ADDENDUM No. 1
Bid Package #1: Construction Documents
Encompass Architects, p.c.

Canopy Row
700 N St., Lincoln, NE 68508
NGC Group

EA Project No.: 16-1100

DATE OF ISSUANCE: February 8, 2017

SECOND FLOOR
PLUMBING -
AREA B/C

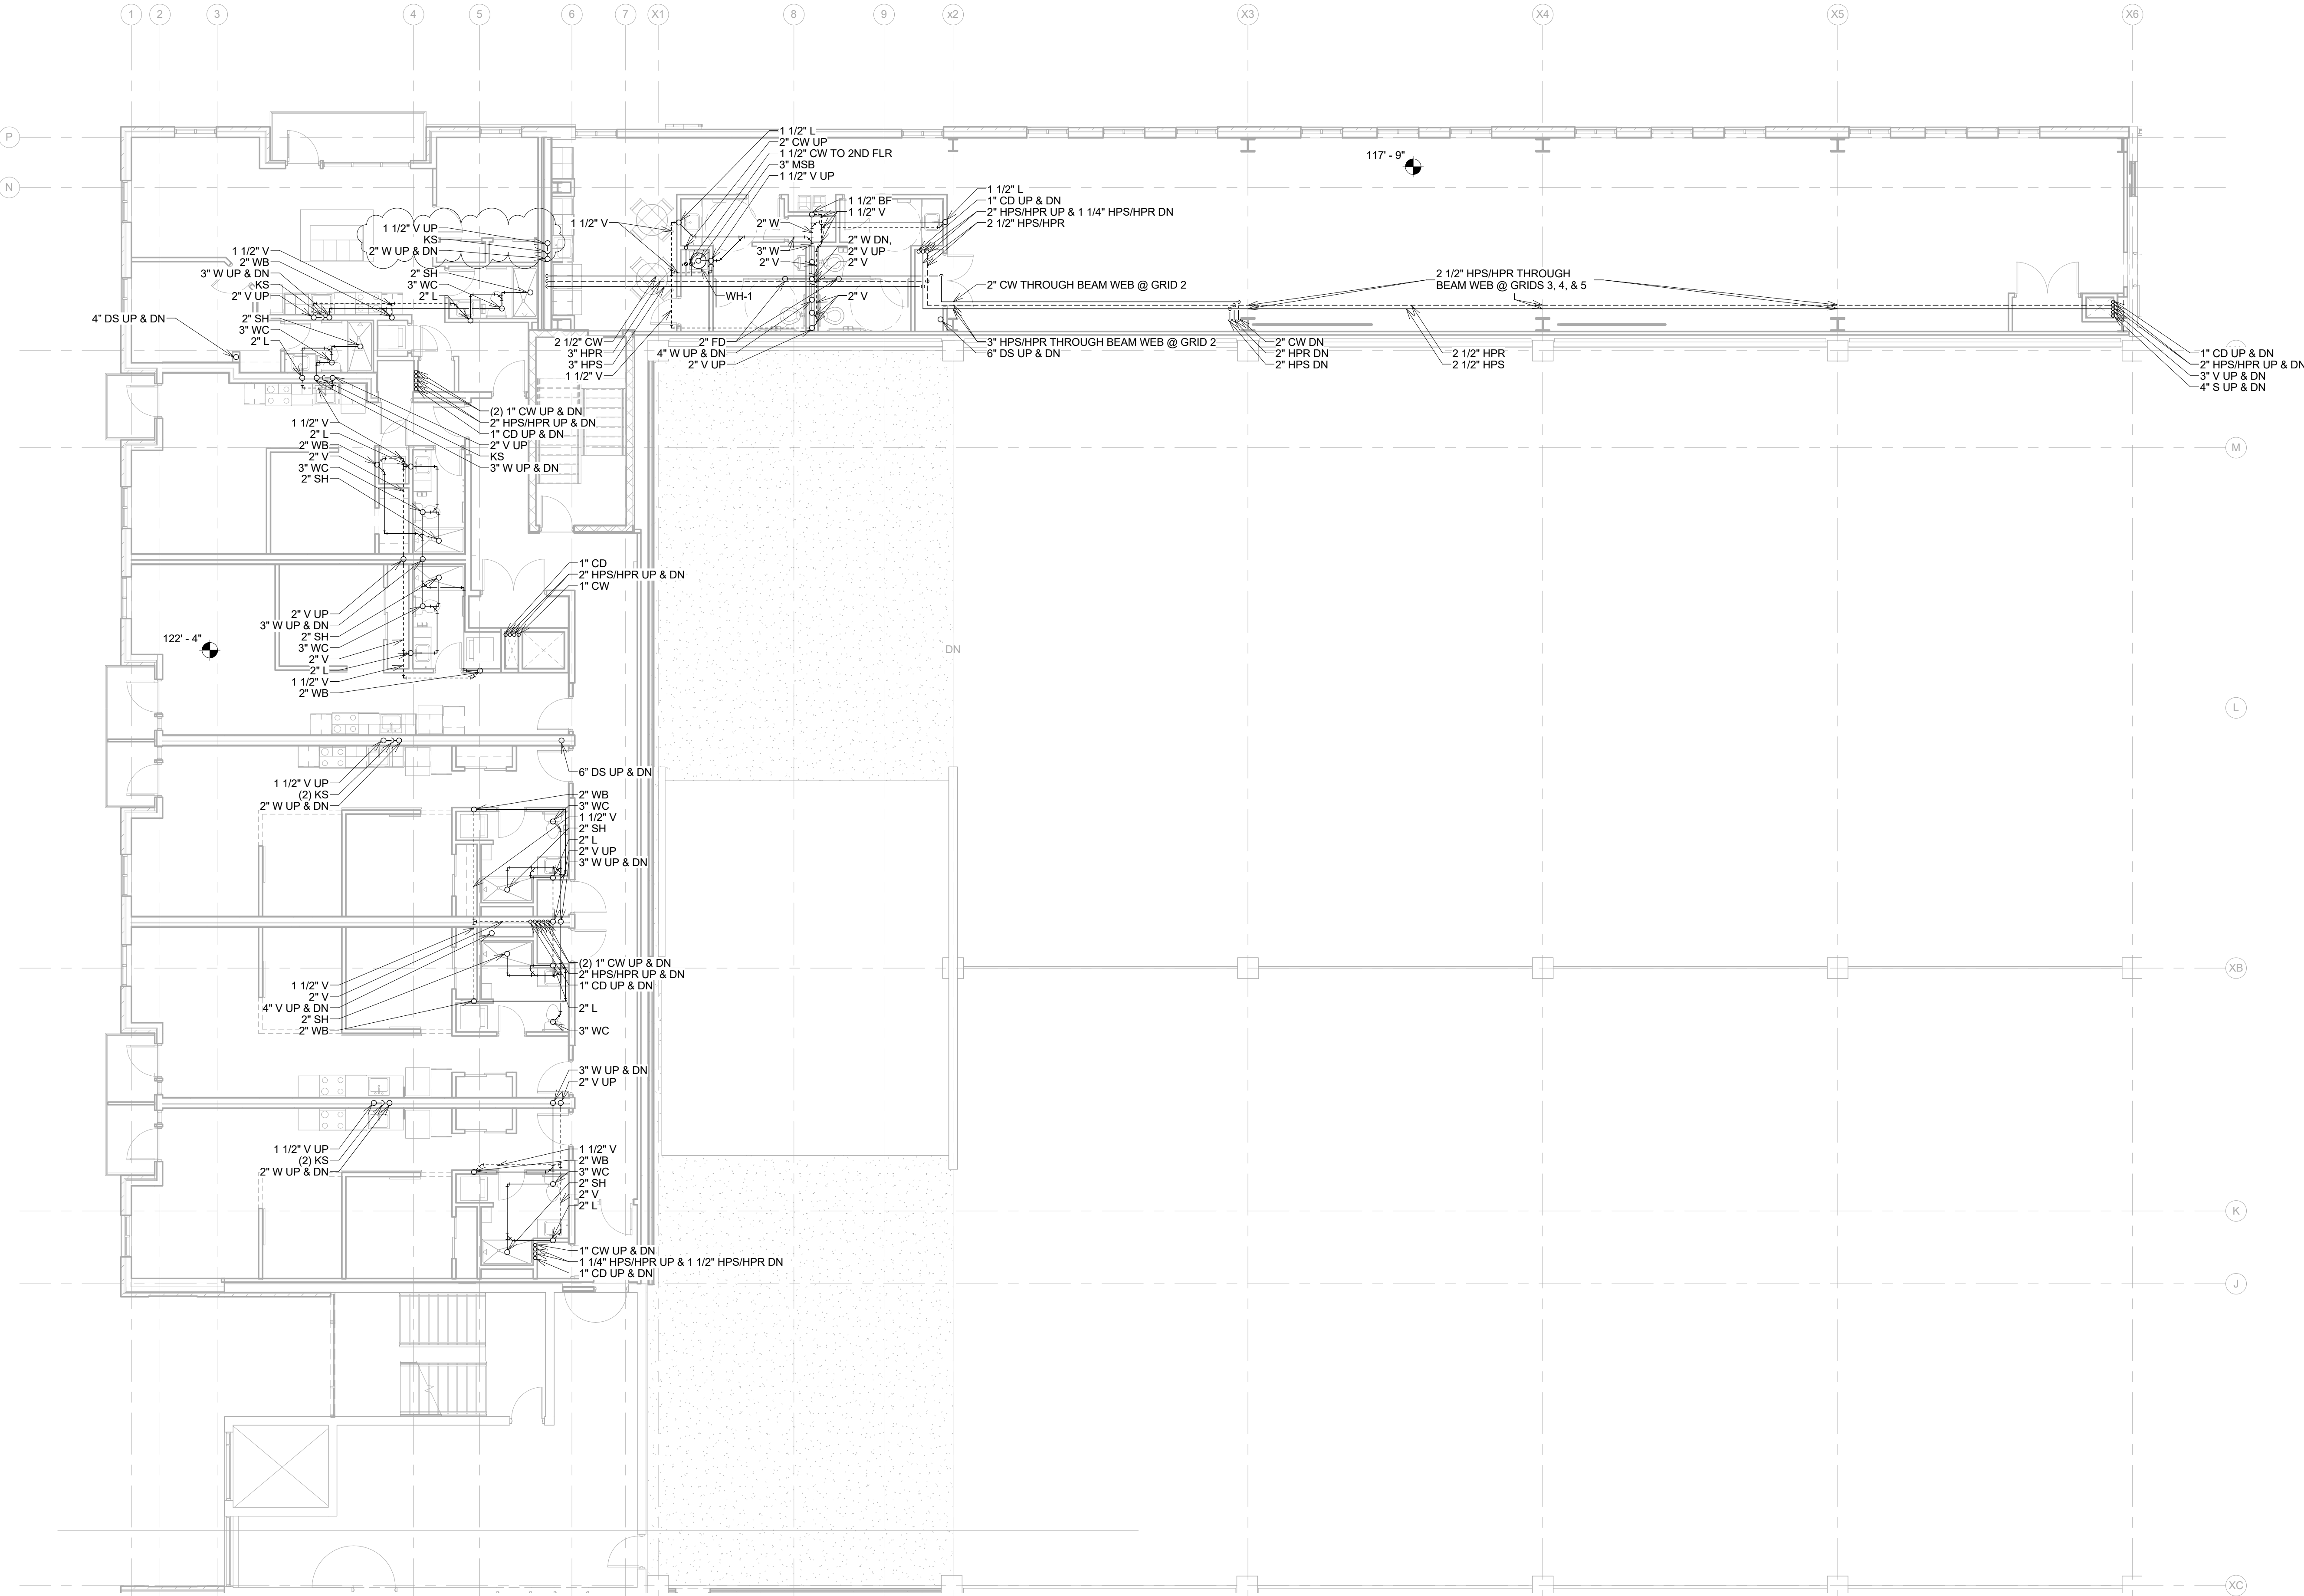
The waste and vent for the kitchen sink in C200 was revised to a waste and vent riser system serving the four sinks on second through fifth floor on single riser system instead of draining each kitchen sink on each floor to the waste and vent stack in the toilet chase in this area.

SECOND FLOOR HANGING PLUMBING
ADDENDUM 1: CHANGE KS IN C200 TO BE ON IT'S OWN RISER (NO LONGER
ATTACHED TO RISER GOING DOWN BATHROOM CHASE. NOW IT'S 2" W UP & DN
PLUS 1 1/2" V UP)-SEE DETAIL 1 (W & V RISER DIAGRAM) ON SHEET M404

M252

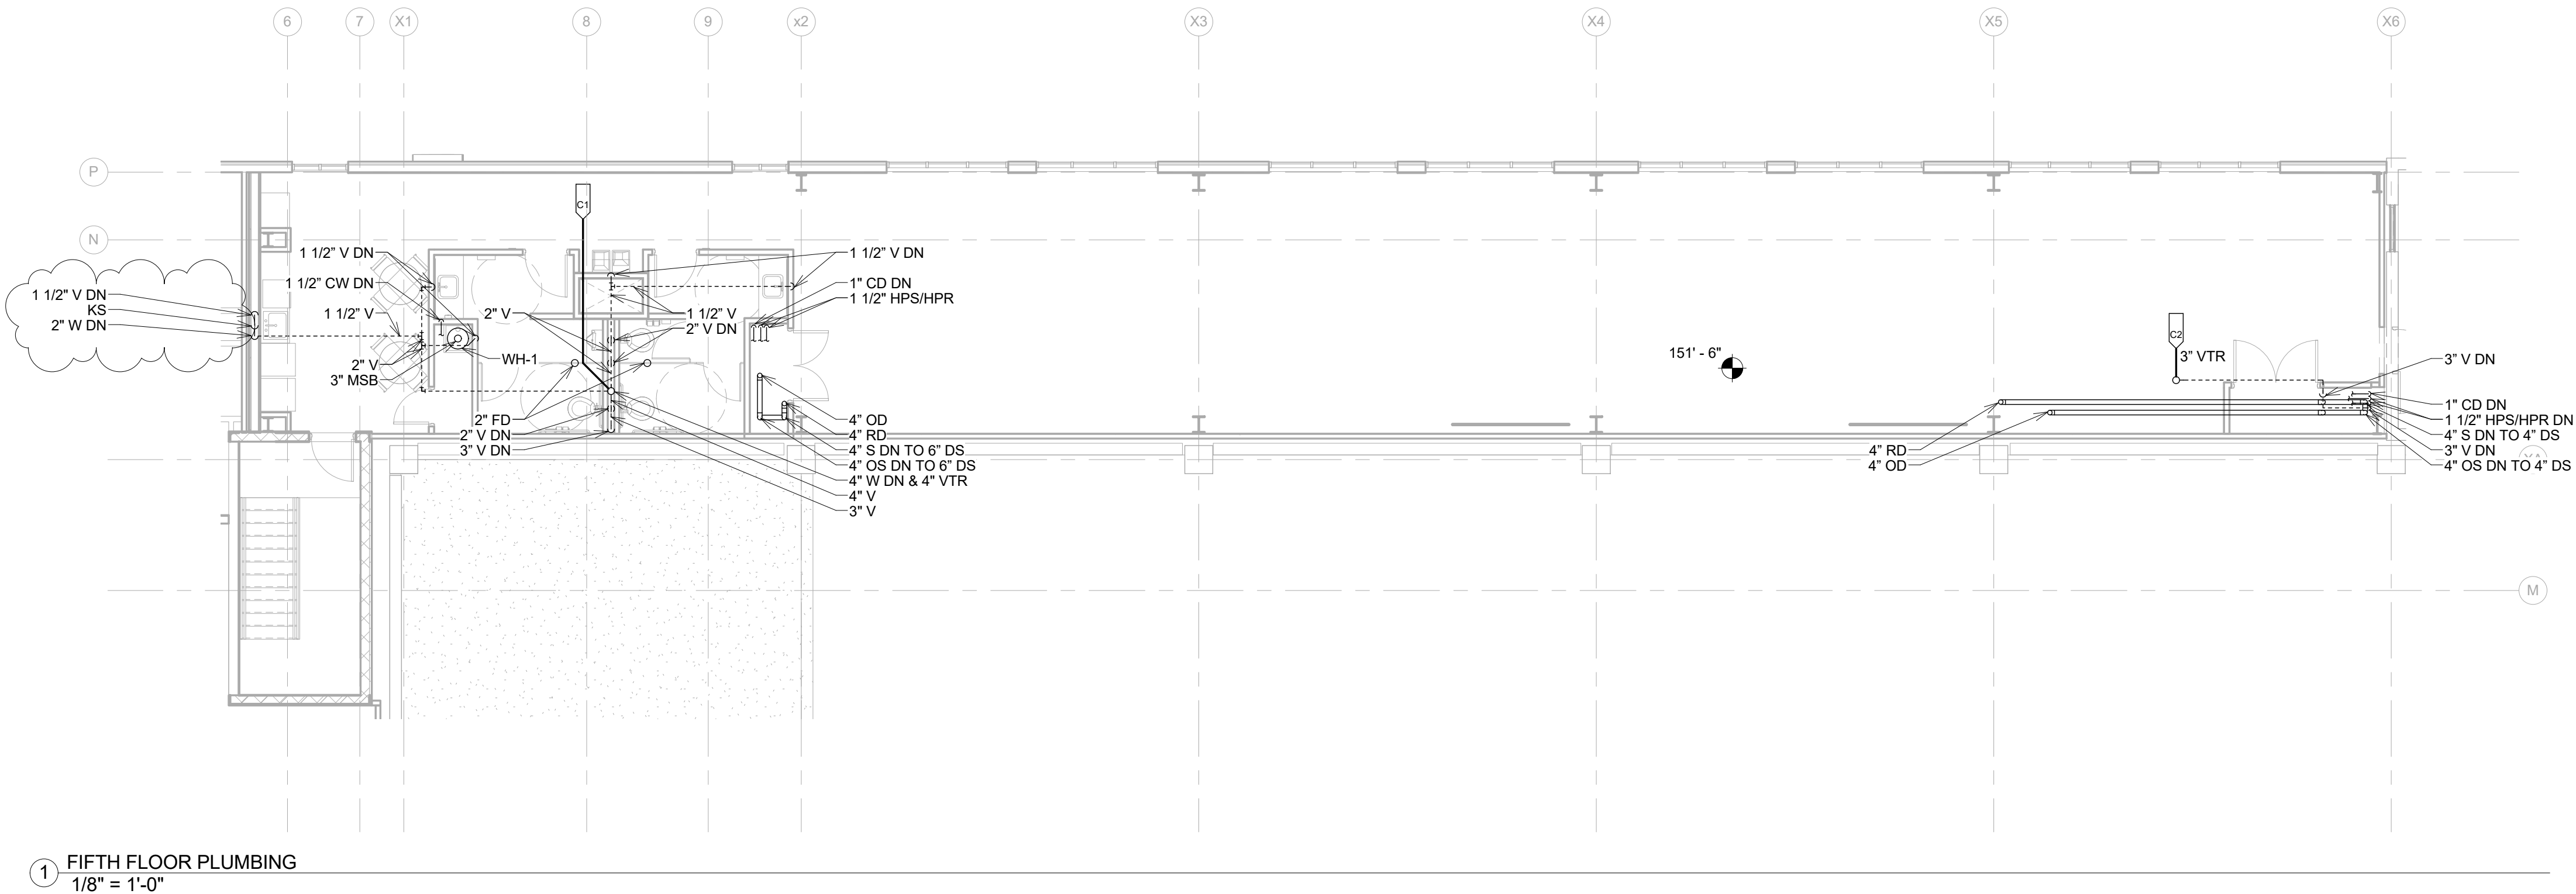
The waste and vent for the kitchen sink in C500 was revised to a waste and vent riser system serving the four sinks on second through fifth floor on single riser system instead of draining each kitchen sink on each floor to the waste and vent stack in the toilet chase in this area.

FIFTH FLOOR HANGING PLUMBING
ADDENDUM 1: CHANGE KS IN C500 TO BE ON IT'S OWN RISER (NO LONGER ATTACHED TO RISER GOING DOWN BATHROOM CHASE, NOW IT'S 2" W DN WITH 1 1/2" V STILL CONNECTING TO BATHROOM RISER TO VTR, BUT NOW IT CONNECTS FROM TOP OF THE NEW 2" W RISER)-SEE DETAIL 1 (W & V RISER DIAGRAM) ON SHEET M404

M332

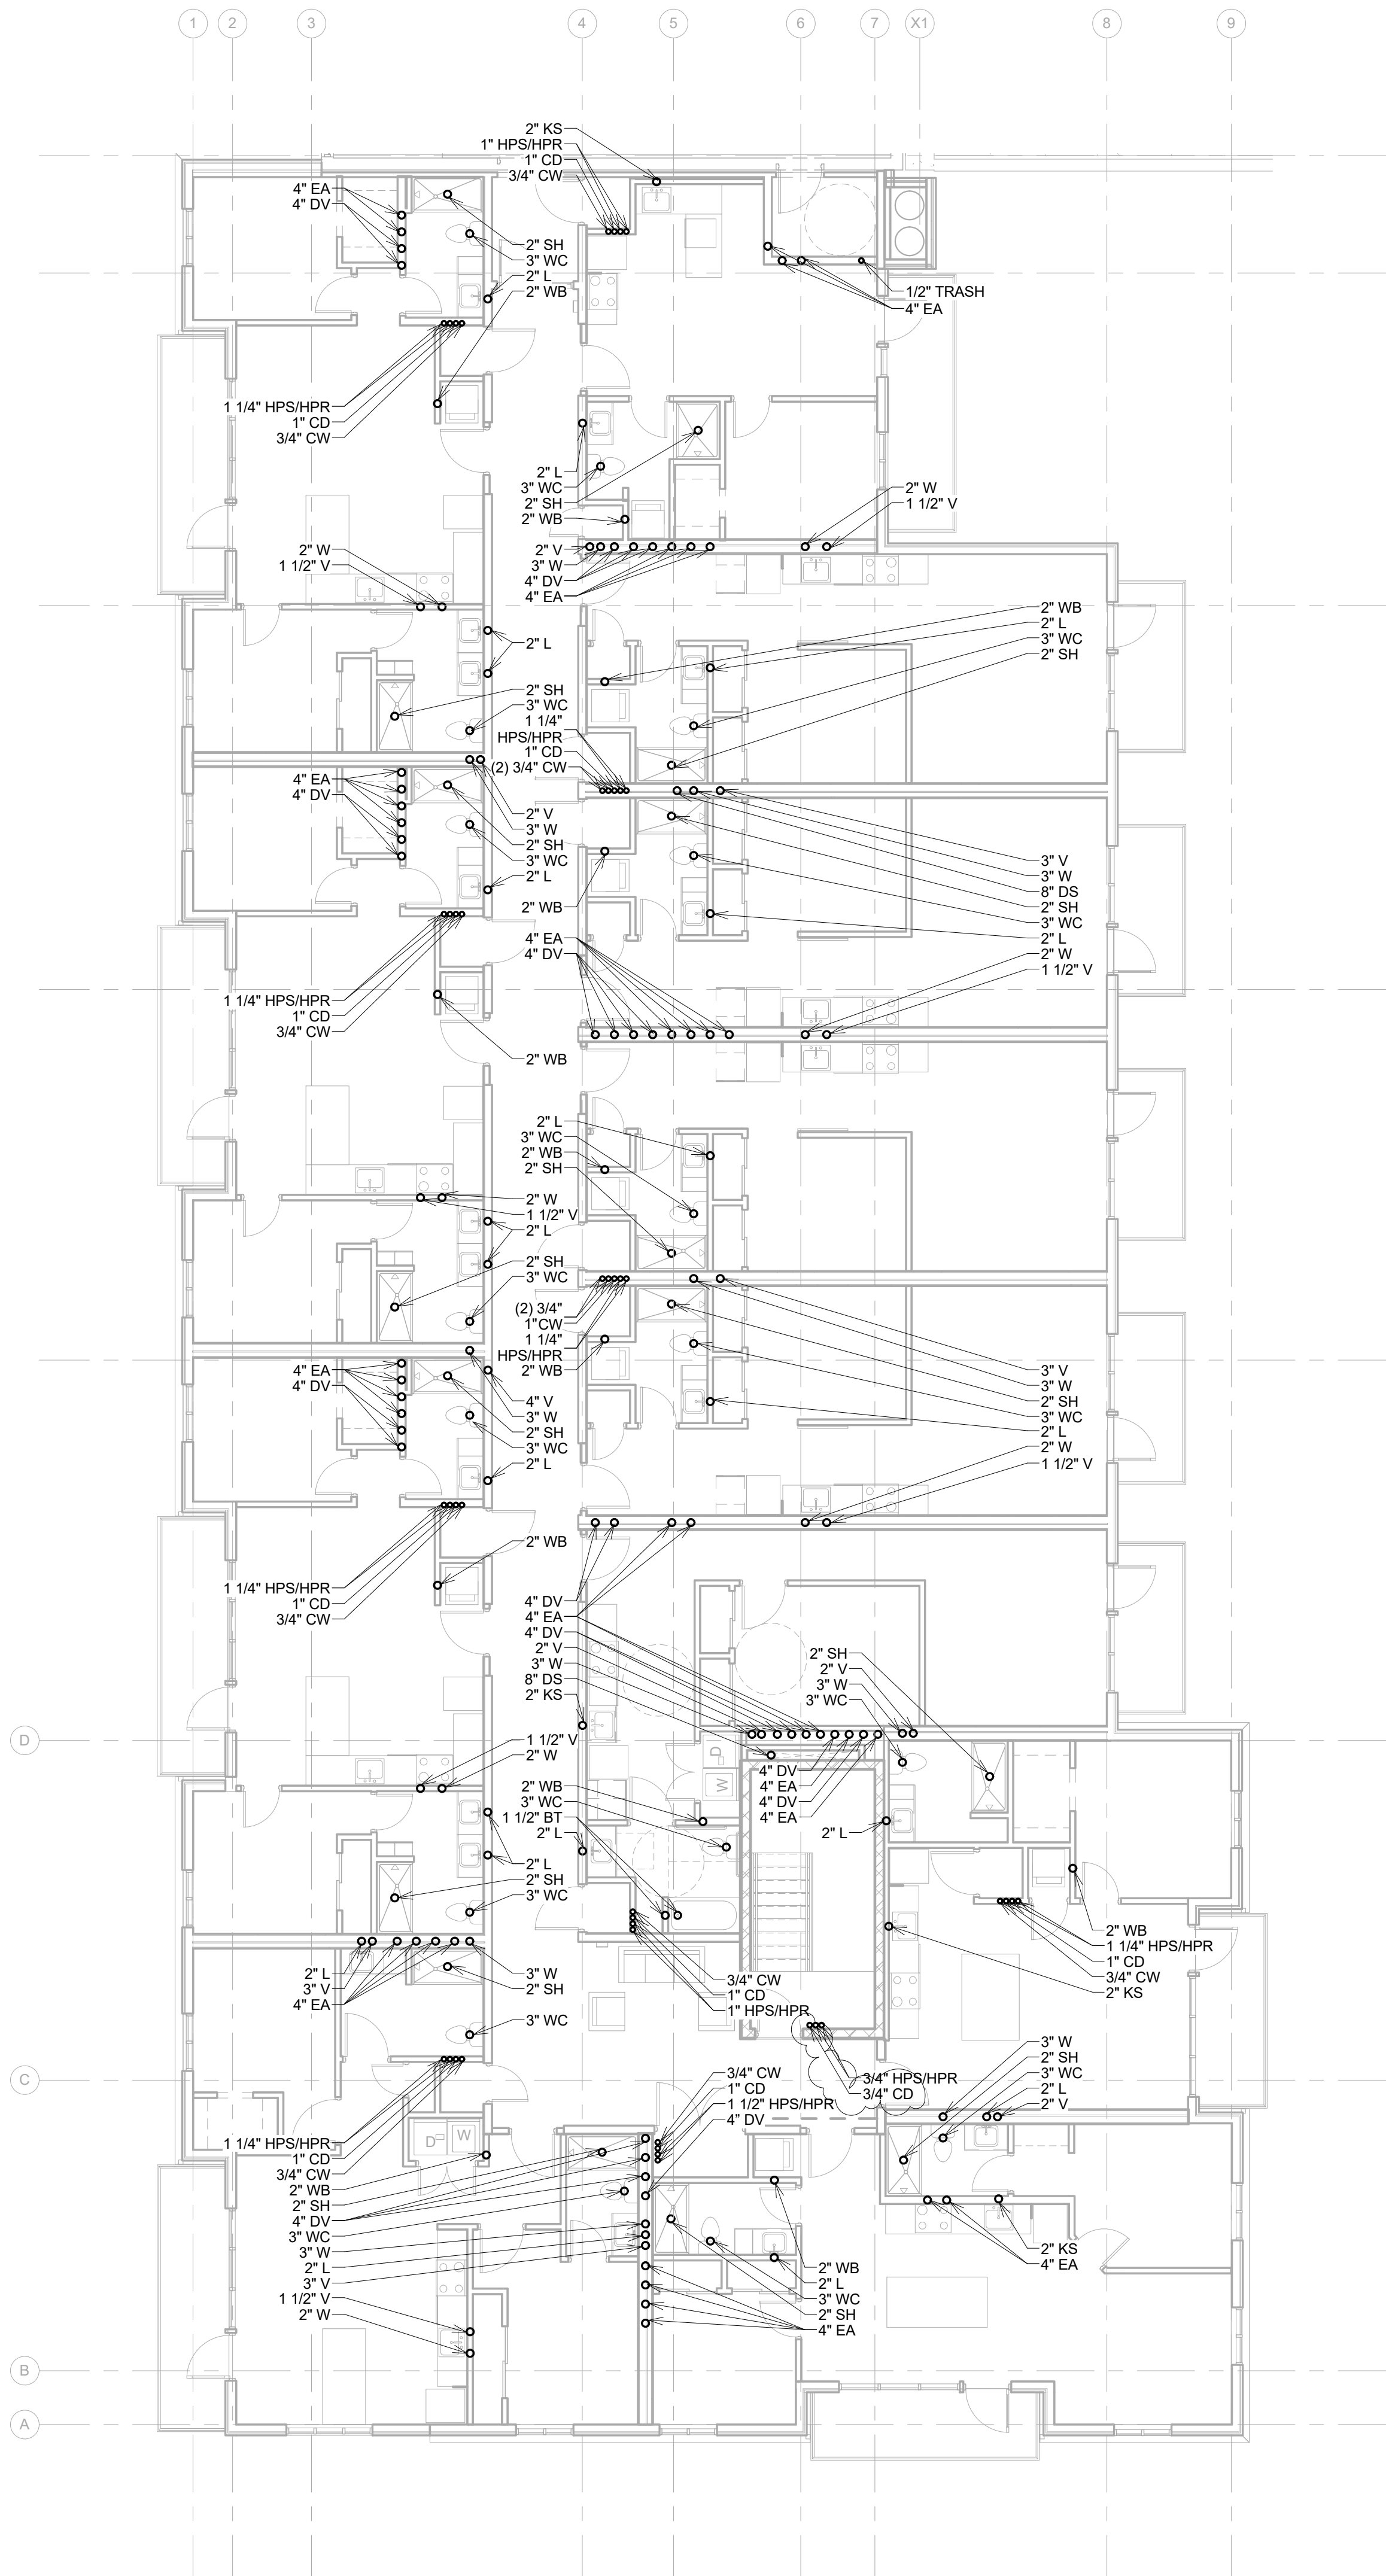
Added 1 ½" vent penetration through the floor for the vent stack for the kitchen sink in C300.

THIRD FLOOR PENETRATIONS
ADDENDUM 1: ADD 1 1/2" V BY KS IN C300
